DESIGN REVIEW TECHNICAL ADVISORY COMMITTEE MEETING

1. **1023 and 1027 6th Street SE**
Sky's Edge Development, LLC (Applicant)
 - Site Plan & Elevations

DESIGN REVIEW TECHNICAL ADVISORY COMMITTEE STAFF REPORT

Date: January 12, 2015
Applicant: Sky's Edge Development, LLC
Owner: Allen Lerch
Location: 1023 and 1027 6th Street SE
Request: Site Plan & Elevation Review
Date Application Received: December 23, 2014

SITE LAYOUT AND DEMOLITION PLAN

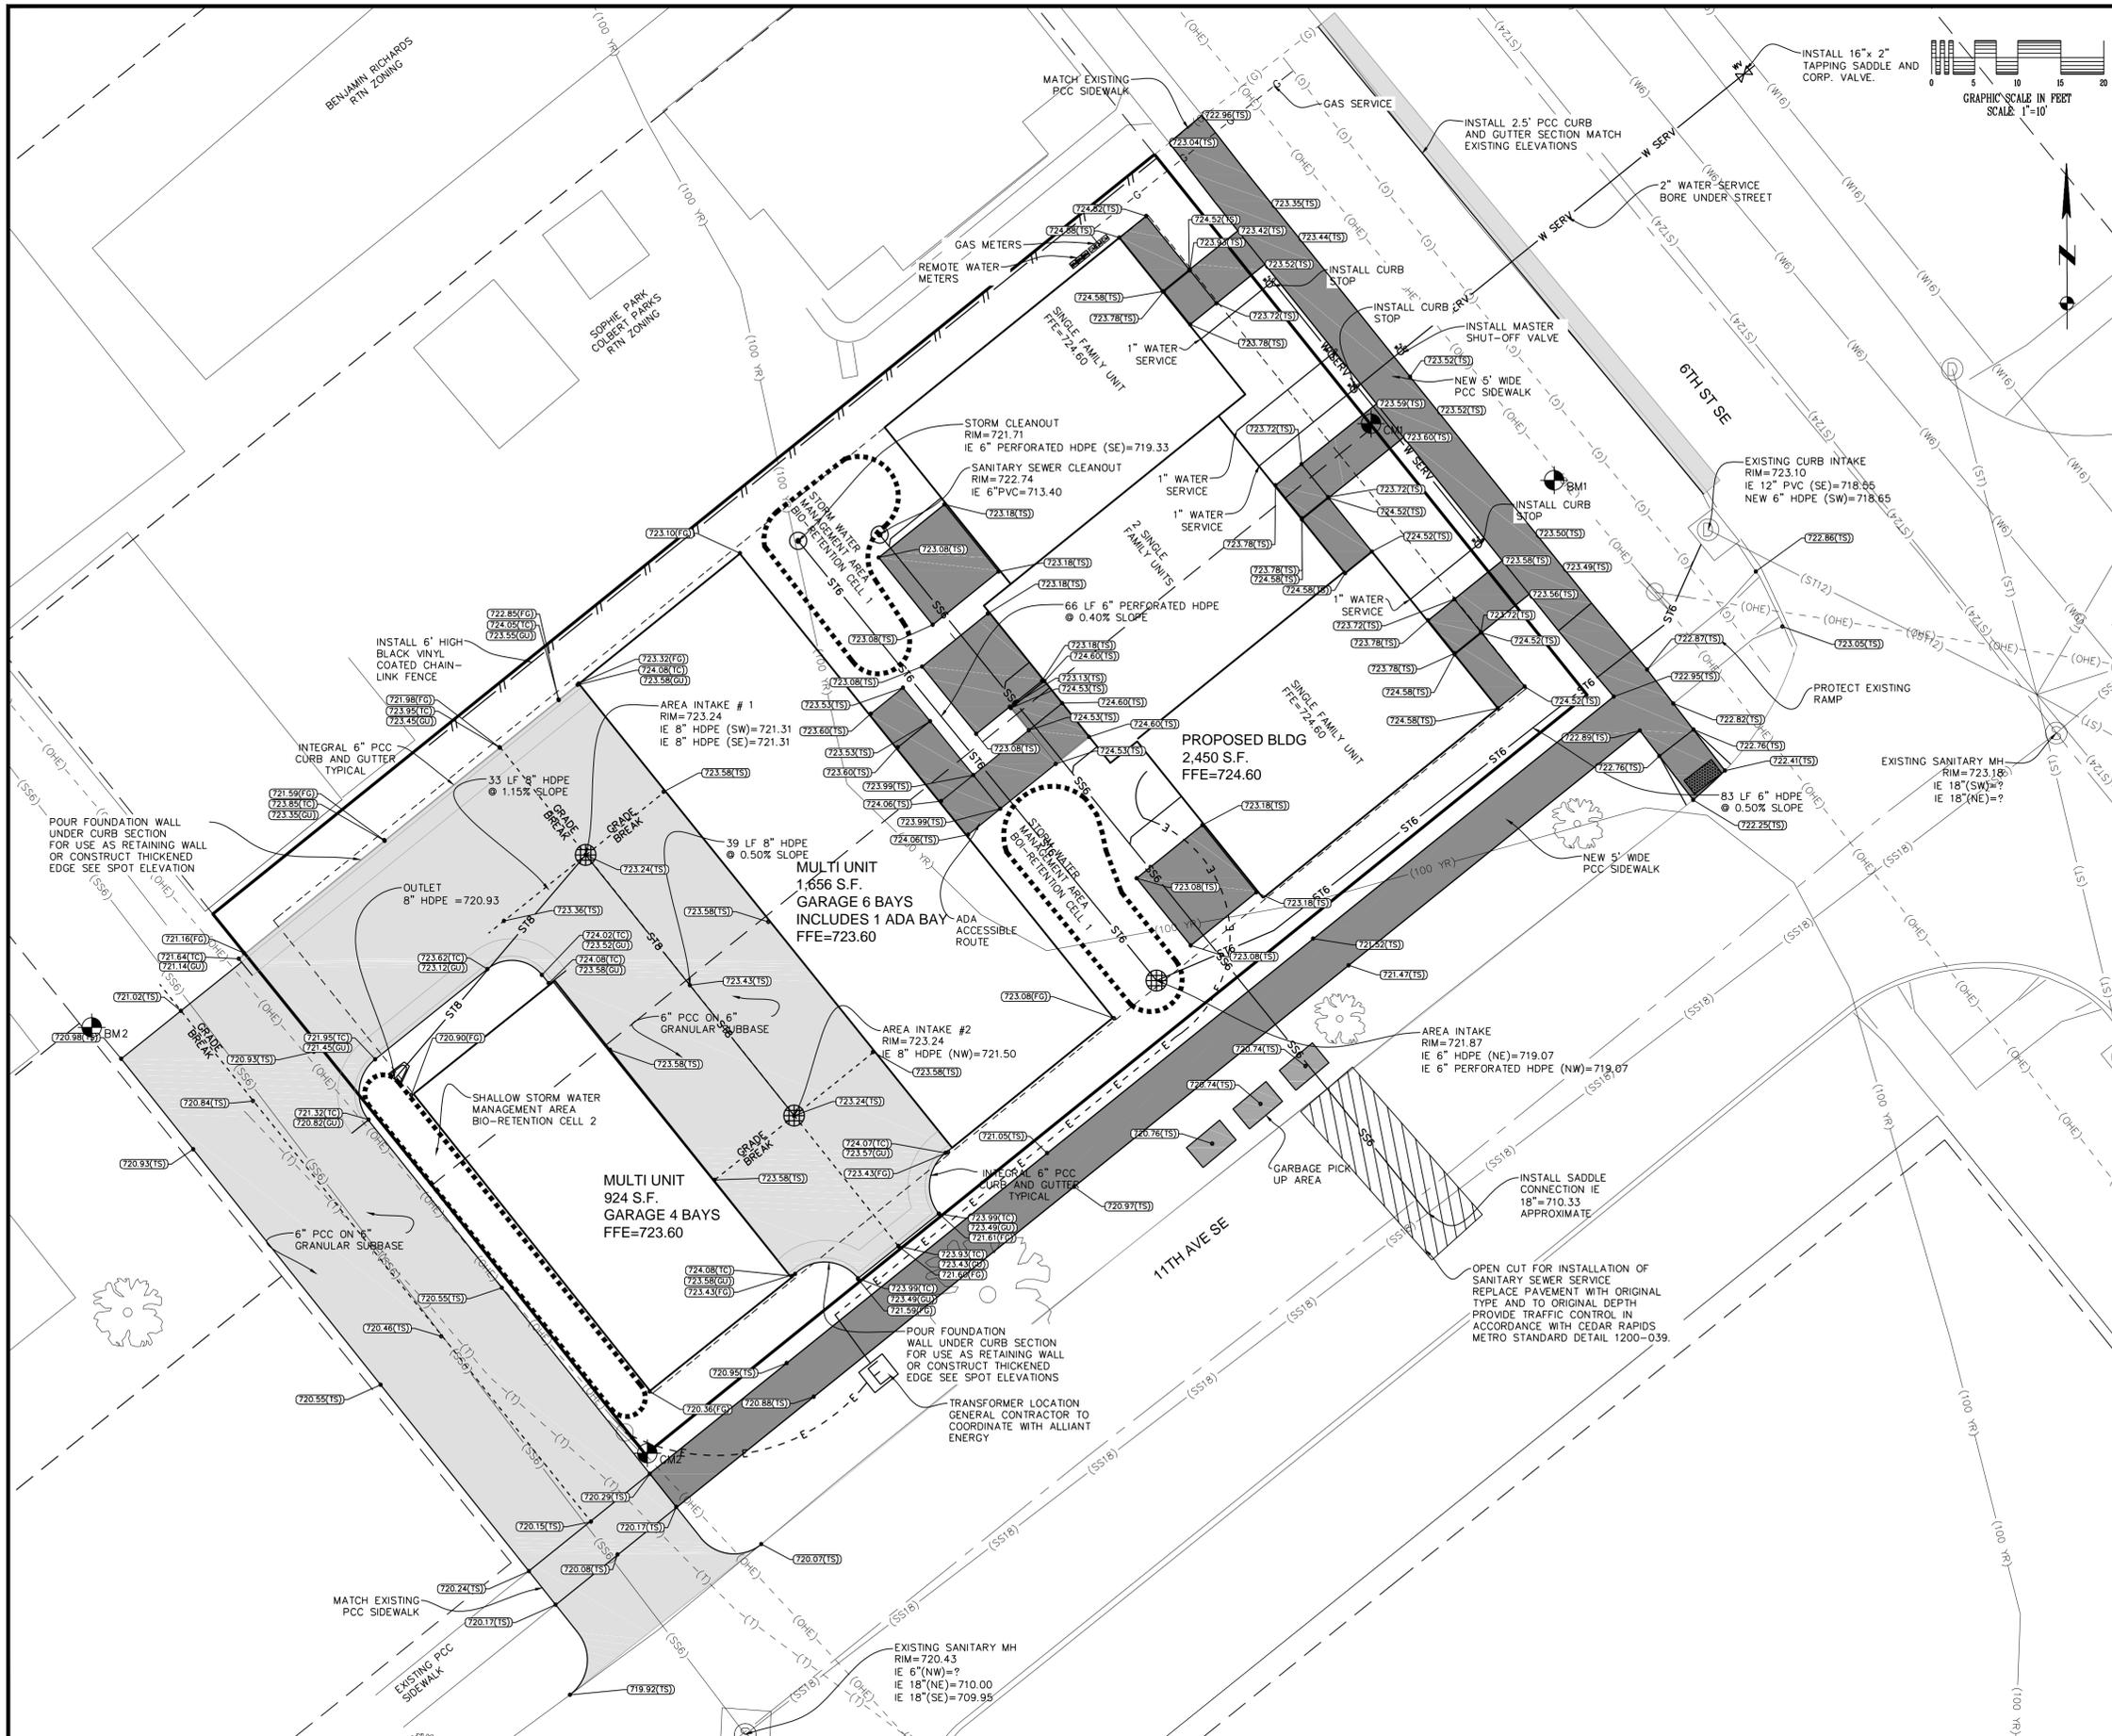
1. There are too many garages on the site. Looks like a rental storage unit facility. Should provide two car spaces per residential unit (8 total) in two buildings of 2 side by side garages with each garage housing 2 cars. (2 buildings/4 cars each) One building justified to the north side yard property line, the other justified to the south property line.
 - Developer has received permission from the City for the 10 parking spaces.
 - These parking spaces are only to be used by the homeowners.
2. # 1 would provide better access for residents to the proposed housing units. If as shown, residents will need to go all of the way around the big garage to get access to the other

- small garage. Would loosen up the site.
3. Will the unit owners be able to fence their back yard? If so, some garage access will only be via public sidewalk from the front door.

LANDSCAPE PLAN 01
 SCALE: 1" = 10' (22"x34" FULL SIZE)

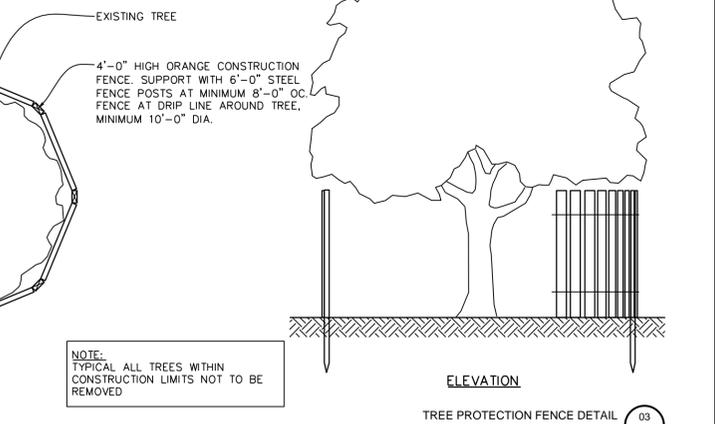
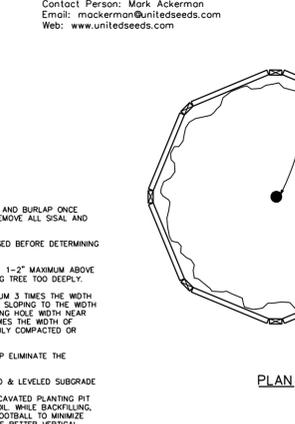
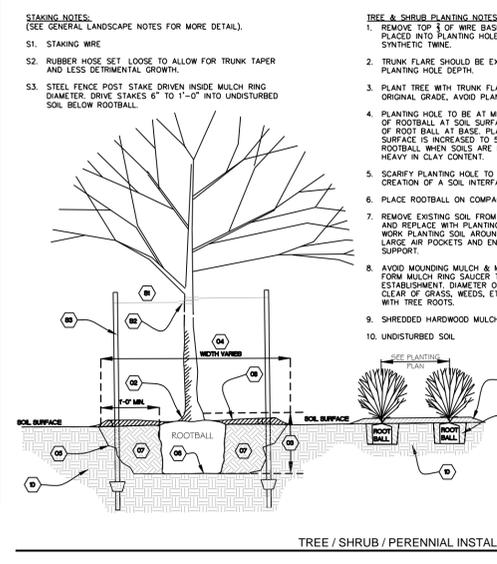
10. The trees and large shrubs are good choices. Please make sure that the two remaining trees are protected with a system that is more structural (ie chain link or other) than the system described.

- The Developer will try to preserve the existing trees on the site.
 11. Is the stone siding accurately represented? Is it a real limestone/brick or a manufactured stone in a random pattern?

South Elevation

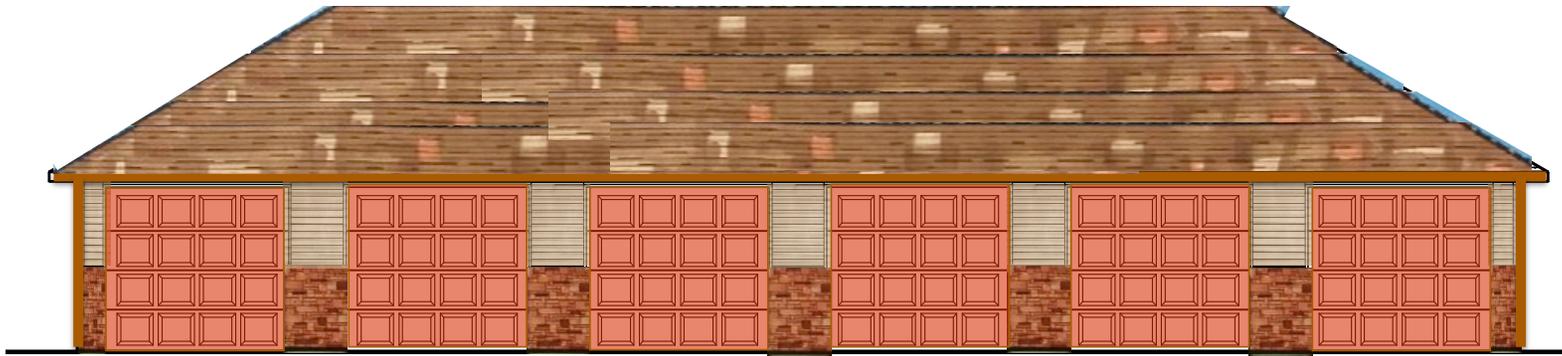
- A variance would be required in order to install fencing. The Developer does not plan to install a fence.
 4. Since the residential bldg. sits on a corner, the south and back side of this building are visible from public R.O.W. Request for trim to be installed around all windows and doors similar to the front of the building. Minimal added cost.

13. DRTAC understands that the ends of the building may not need windows but some attention to detail on the street facing side should be explored. Including the window trim on the front around to the sides would help.

- All of the windows and doors will have a trim. The Developer will consider installing an additional window on each side of the building.
 14. The Developer was reminded that he will need to come before DRTAC if changes are made to the building design.
